**CALIFORNIA COASTAL COMMISSION**

## **A-5-LGB-19-0015 (LAGUNA CANYON CREEK EROSION)**

**OCTOBER 17, 2019**

### **EXHIBITS**

**LEGEND:**

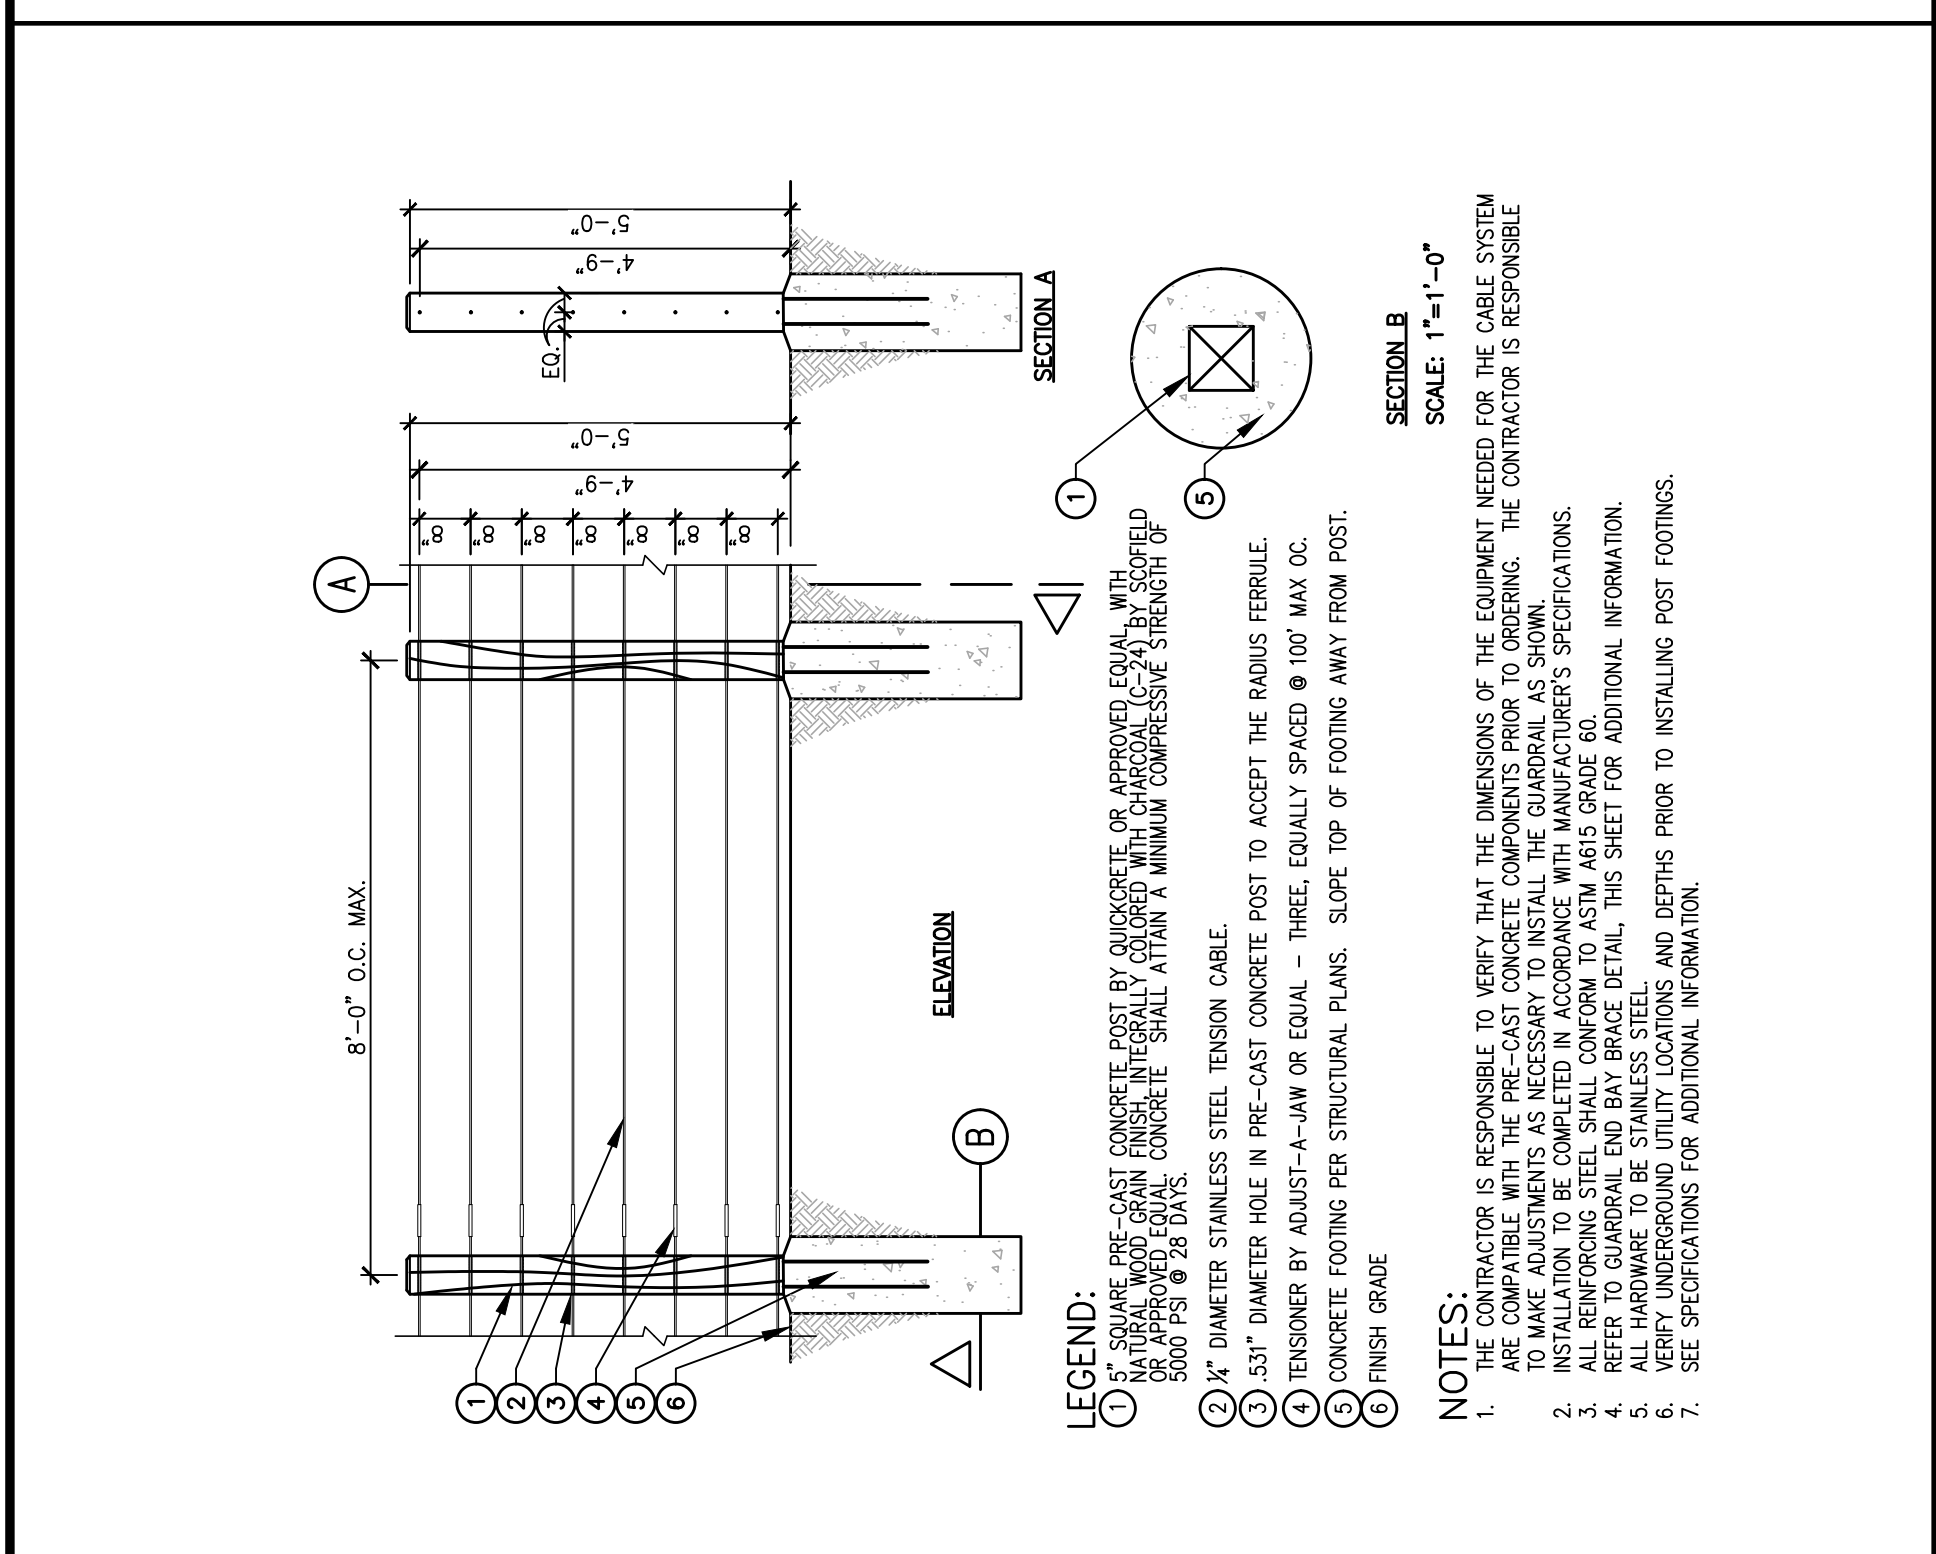
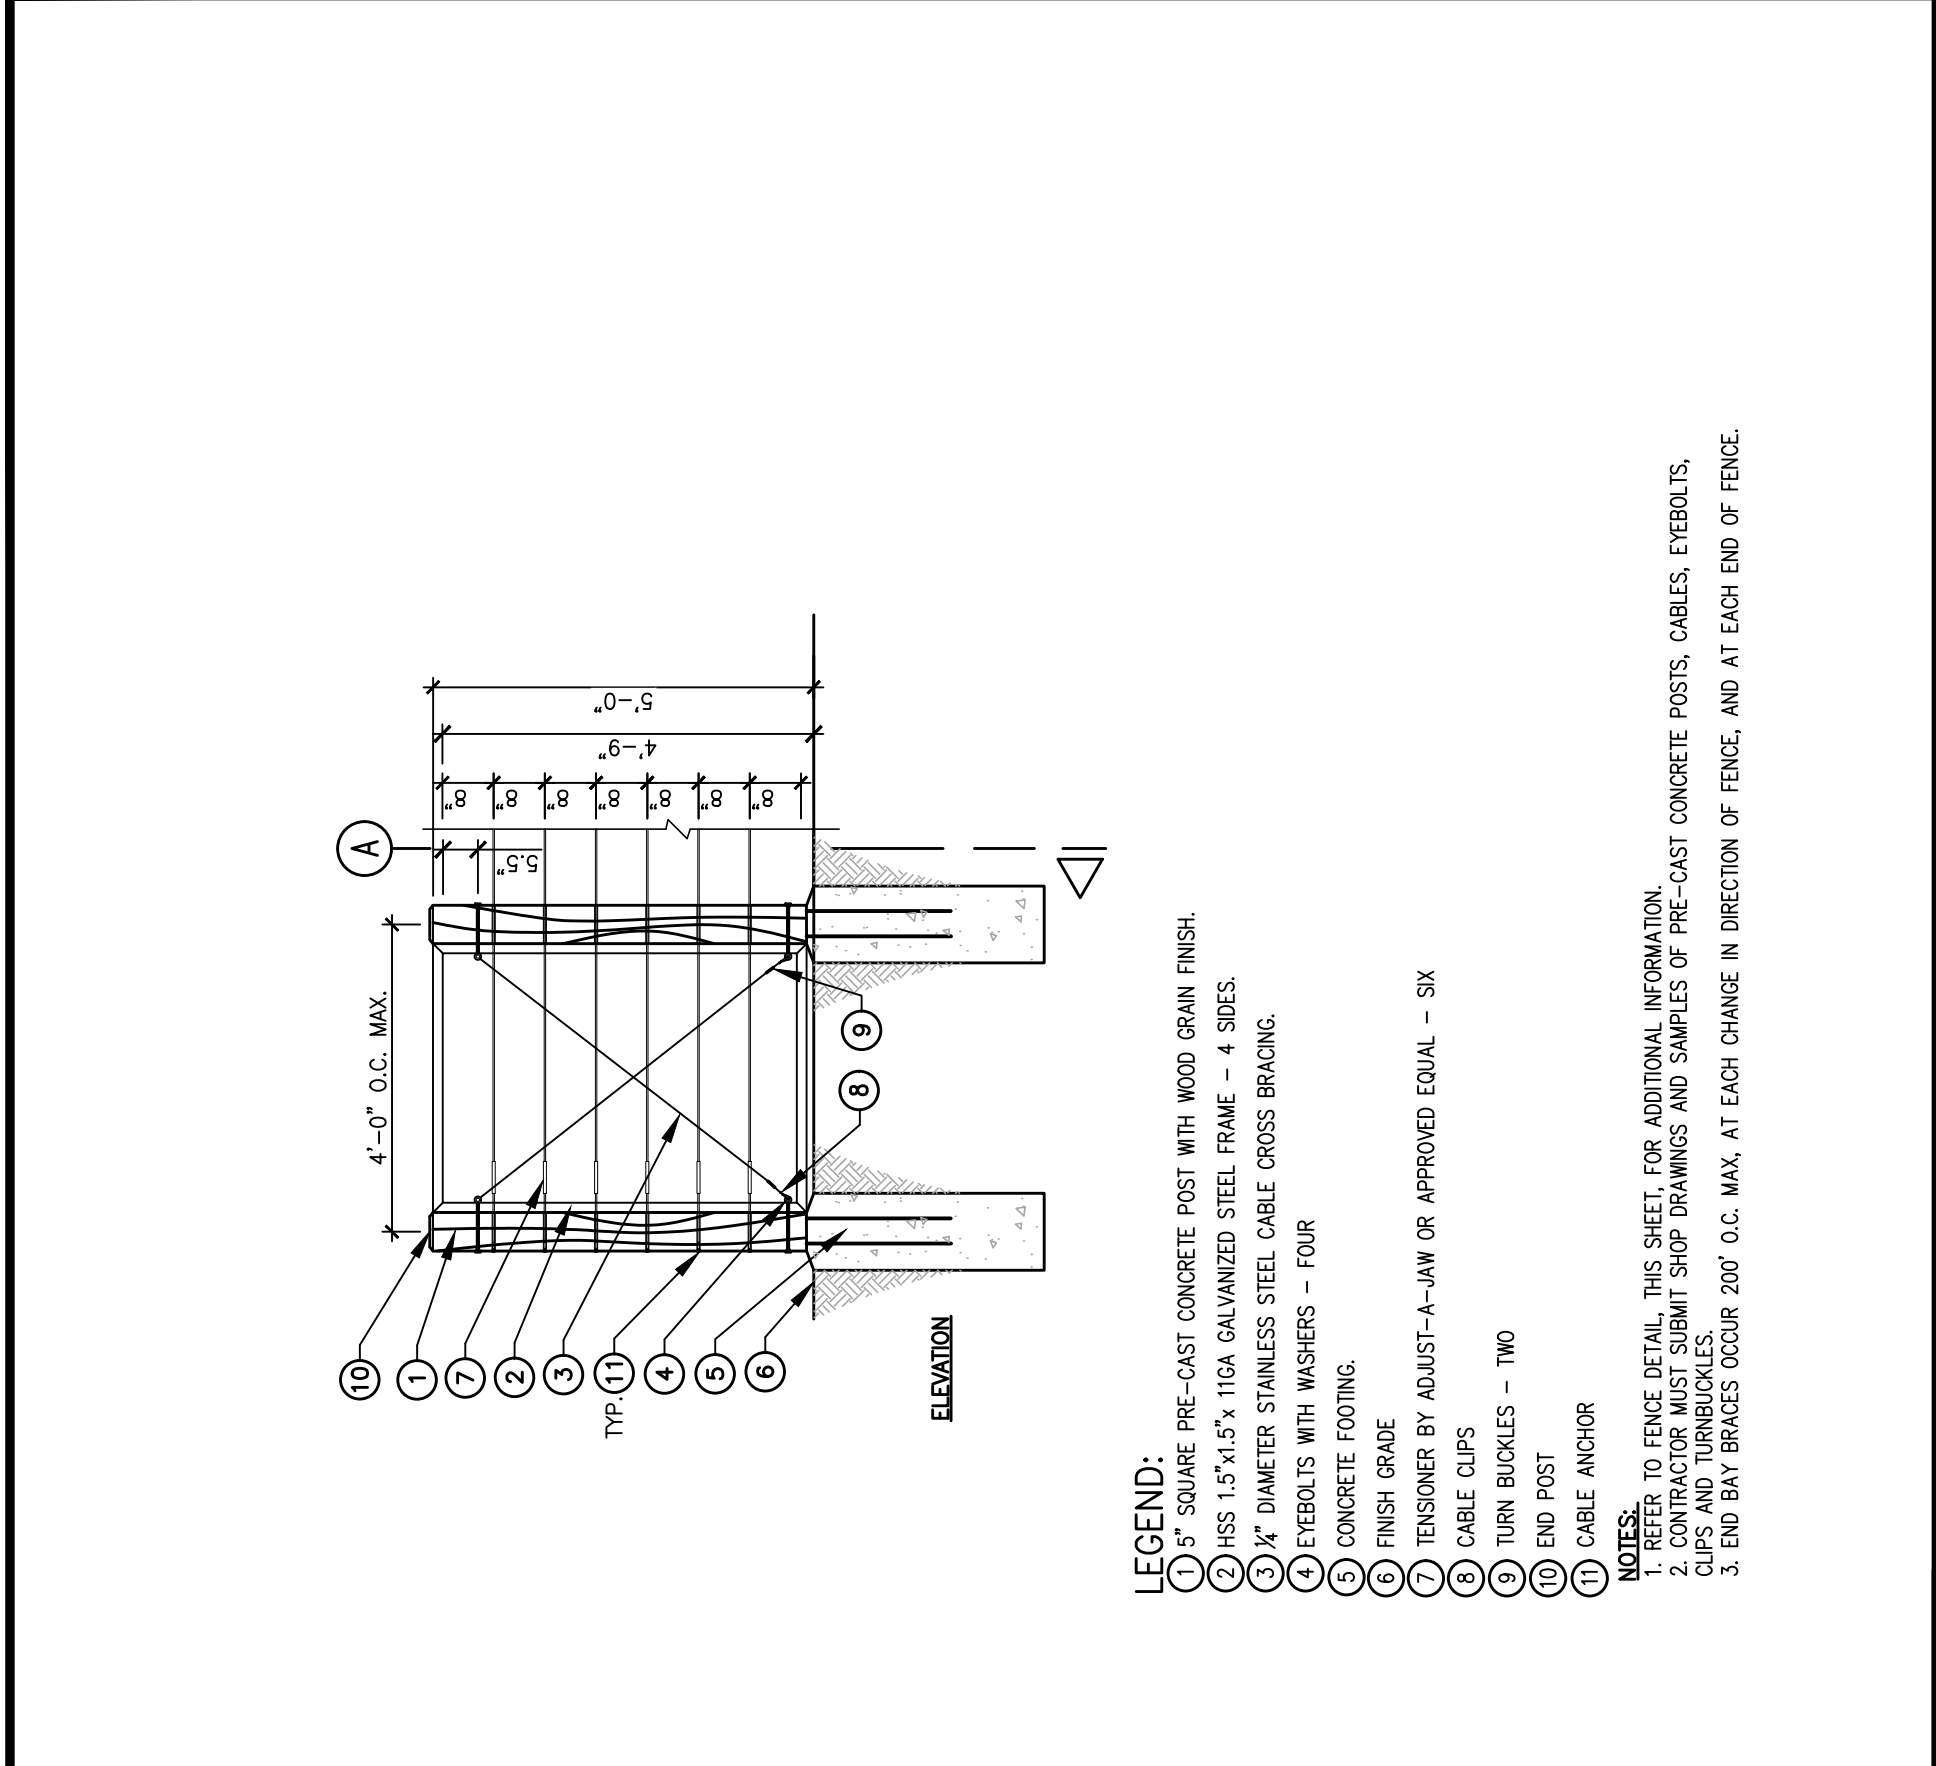
The proposed pedestrian bridge will be a conventional steel truss bridge with a weathered look to blend in with the surrounding environment (see plan sheet 5). The cable railing is attached to wood-textured concrete posts that will be mounted on top of the retaining wall. Cable railing was chosen to minimize view impacts. The retaining wall will be dark tan split-face masonry finish. The perimeter fence will be of a wood fence cross-buck style. All the finishes will contribute to enhance the natural aesthetic of the creek environment.
